**STAFF RECOMMENDATION**

**1626 Shelby Avenue  
December 21, 2016**

**Application:** New construction—outbuilding  
**District:** Lockeland Springs-East End Neighborhood Conservation Zoning Overlay  
**Council District:** 06  
**Map and Parcel Number:** 08314036000  
**Applicant:** Matthew Shutz  
**Project Lead:** Melissa Baldock, melissa.baldock@nashville.gov

**Description of Project:** Application is to construct a four hundred and twenty-seven square foot (427 sq.ft.) outbuilding. The outbuilding will not be used as a Detached Accessory Dwelling Unit.

# 1 | ELEVATIONS

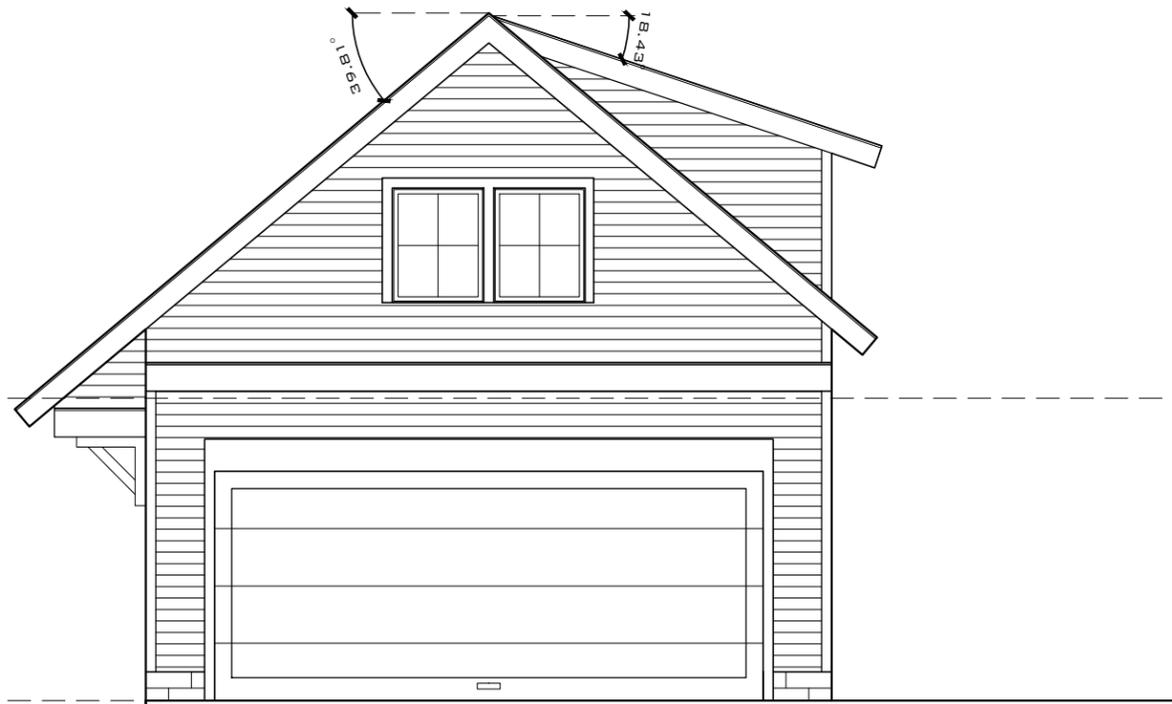
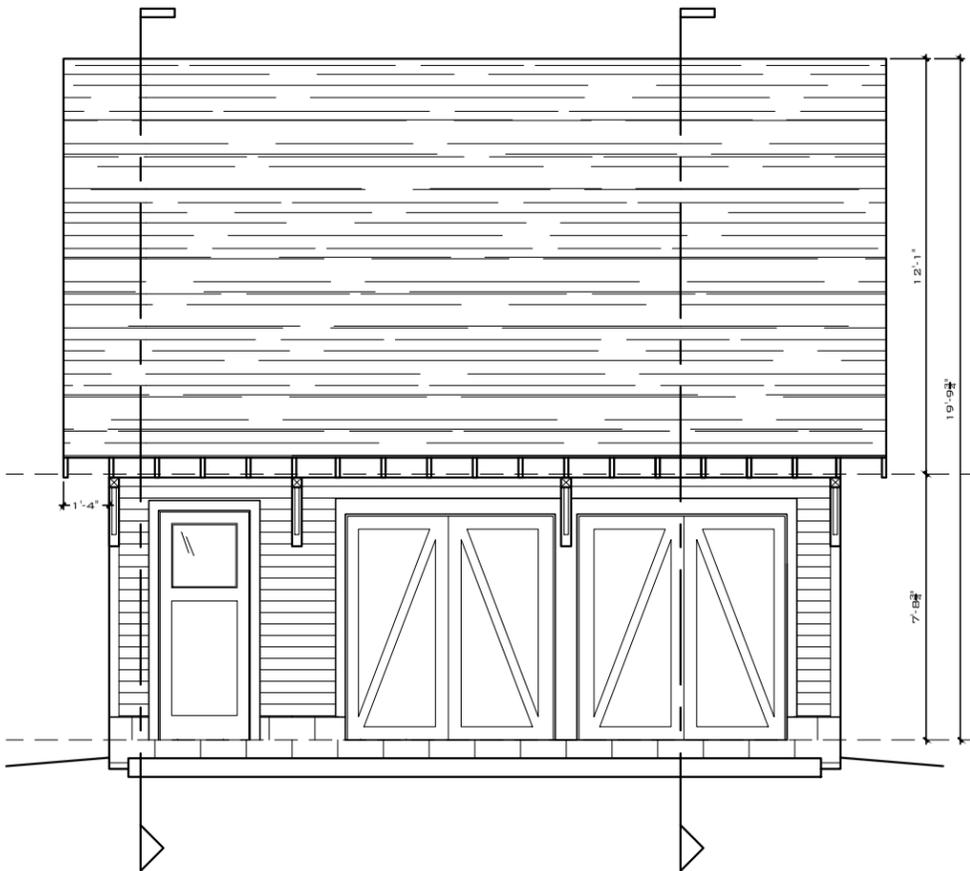
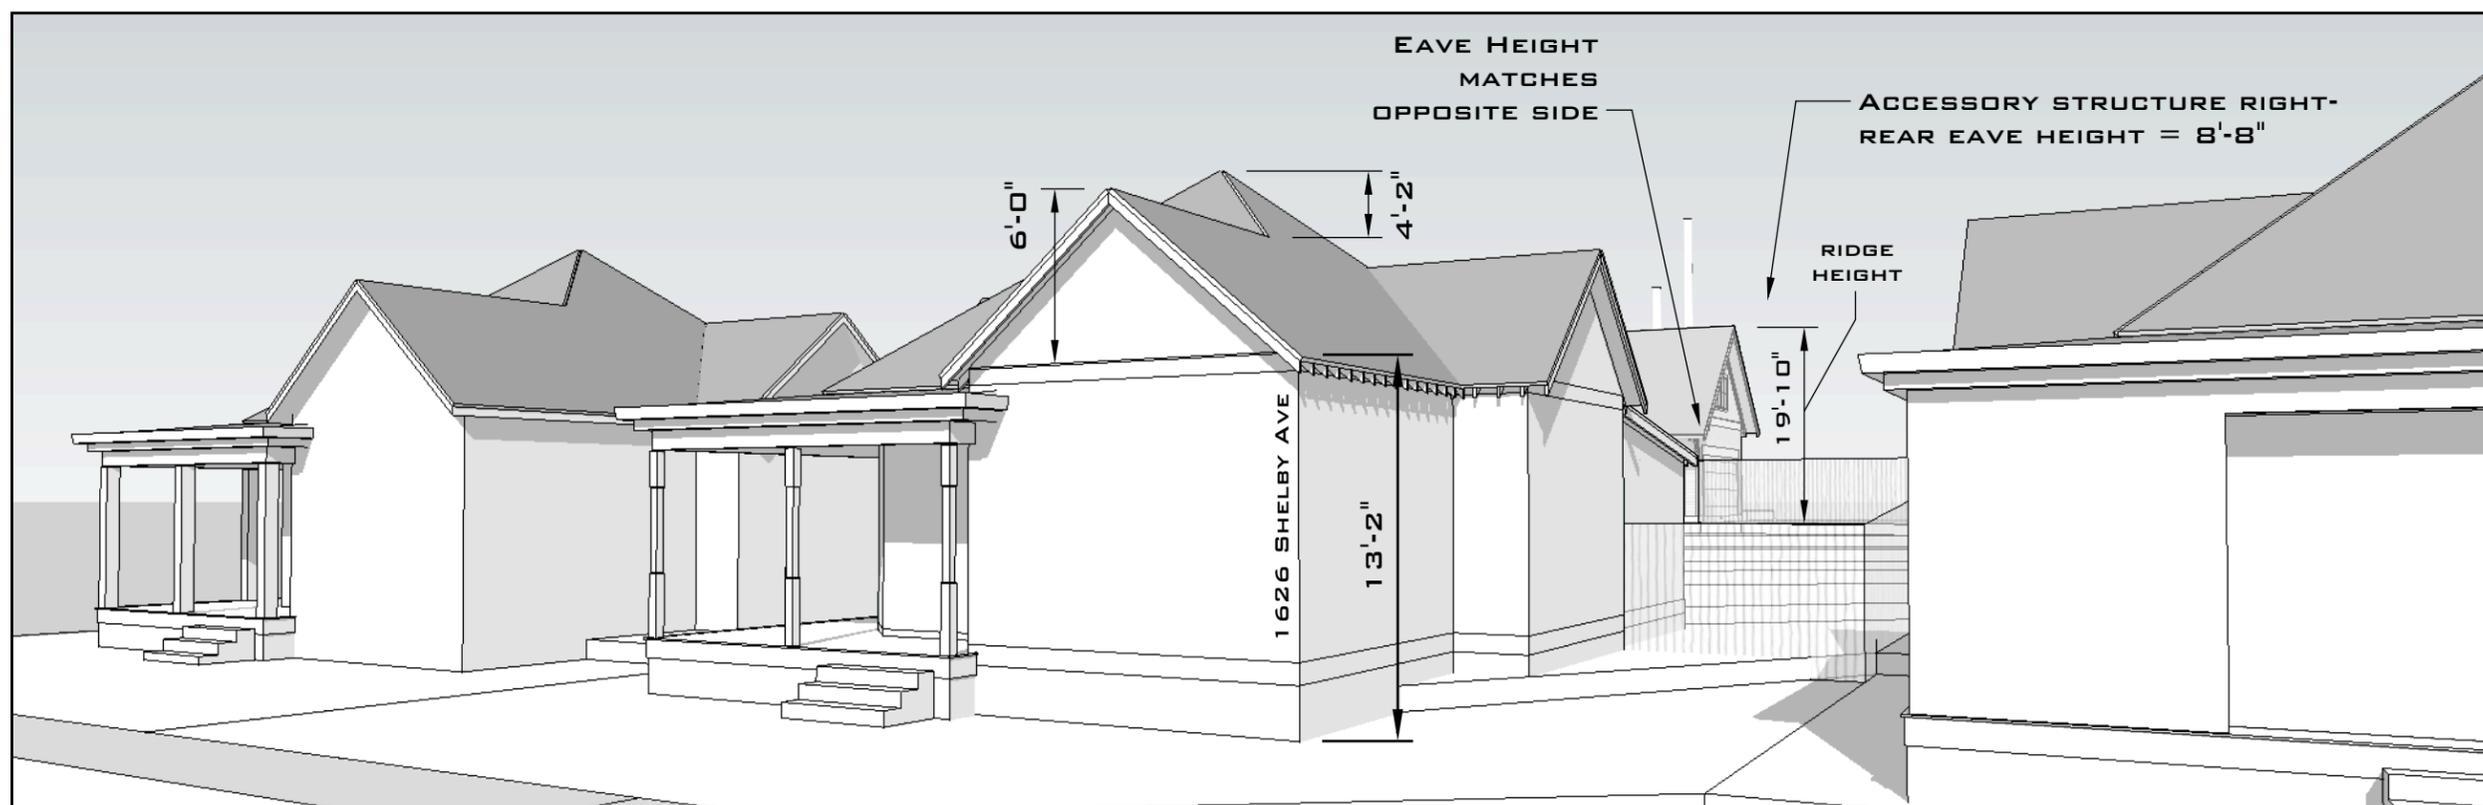
\*The garage is designed so that it has lower eave heights facing the house and Shelby Avenue and a taller eave height facing the alley. In this instance, the eave heights facing the house/Shelby Avenue are approximately seven feet, nine inches (7'9") tall from the average grade. The eave heights facing the alley are ten feet (10') on one side and

fourteen feet, three inches (14'3") on the other side. Although the fourteen feet, three inch (14'3") eave is taller than what is typically approved, staff finds it to be appropriate in this instance because the average of the outbuilding's four eaves is ten feet (10'), which meets the design guidelines. In addition, the taller eave height faces the alley and will at most be minimally visible from the public street. Also, the building is significantly smaller in footprint (427 sq. ft.) than most outbuildings requested, which are typically seven hundred to seven hundred-fifty square feet (700-750 sq.ft.). The overall scale of the outbuilding is appropriate.
